Comments on Parcel Group 6 Master Development Plan

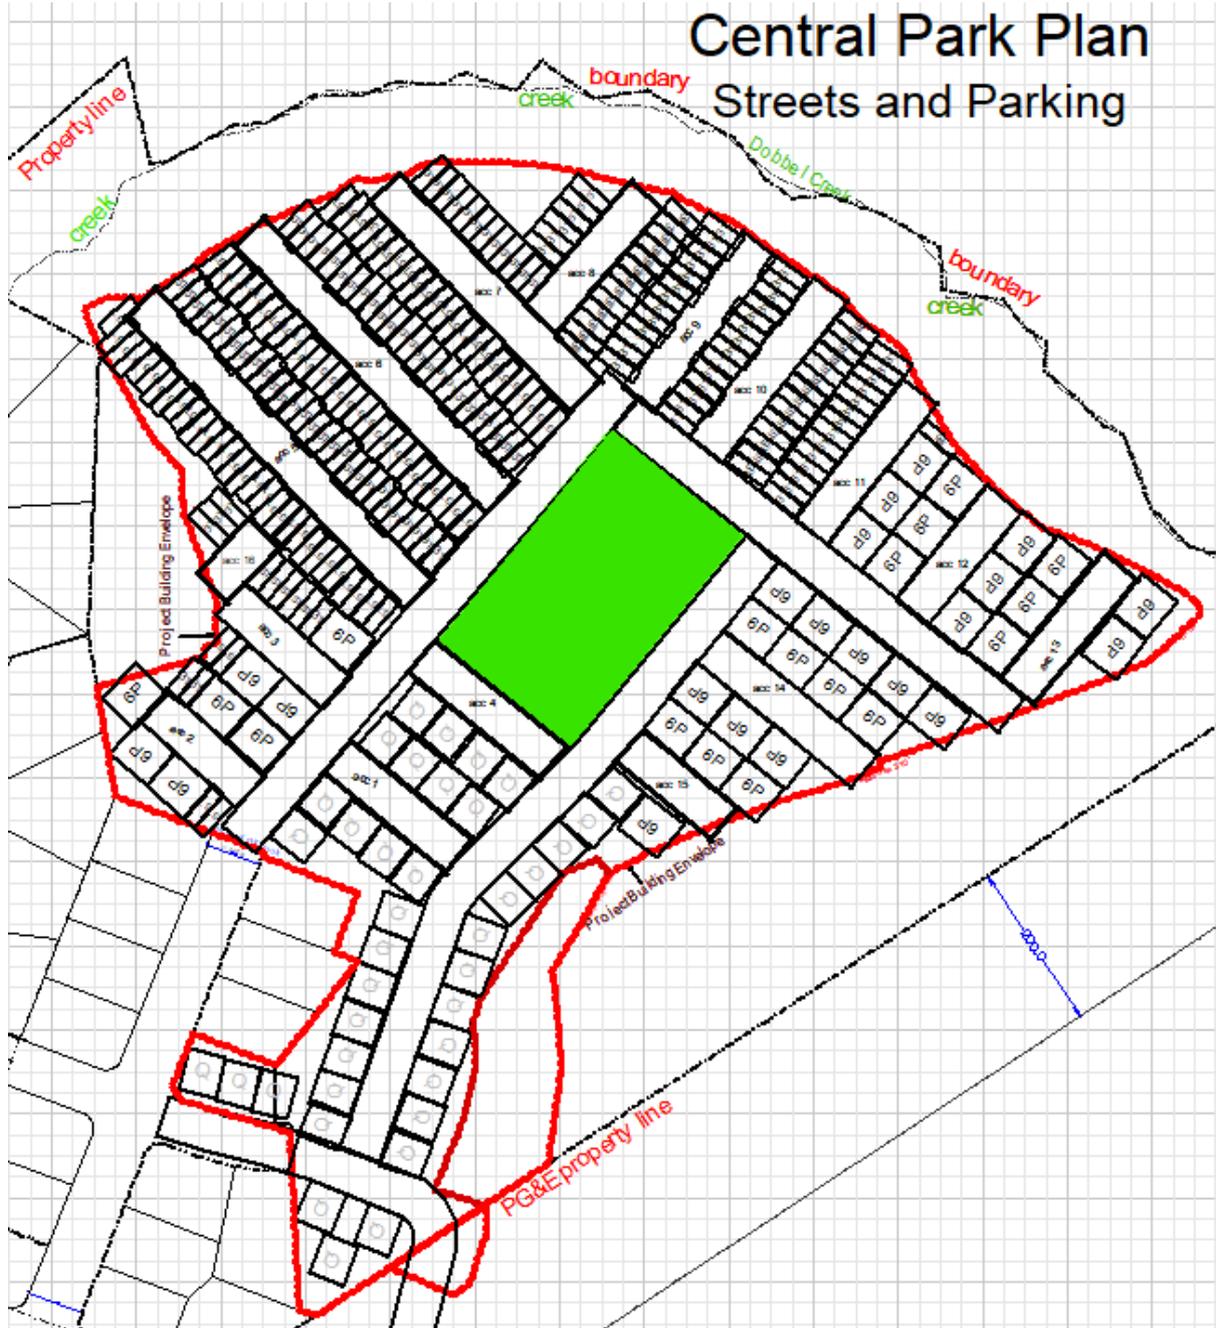
p. 27: "An approximately 1.5-acre neighborhood park;" p. 21: "would" should be "could" because a large central park which looks good on paper does not follow the principals for the use of public spaces set out by William Holly Whyte (<https://www.pps.org/>). The same park area works better in smaller areas closer to front doors, which also allows more efficient use of the site and does not preempt land need for housing. "Easily accessible" by car is different from by walking.
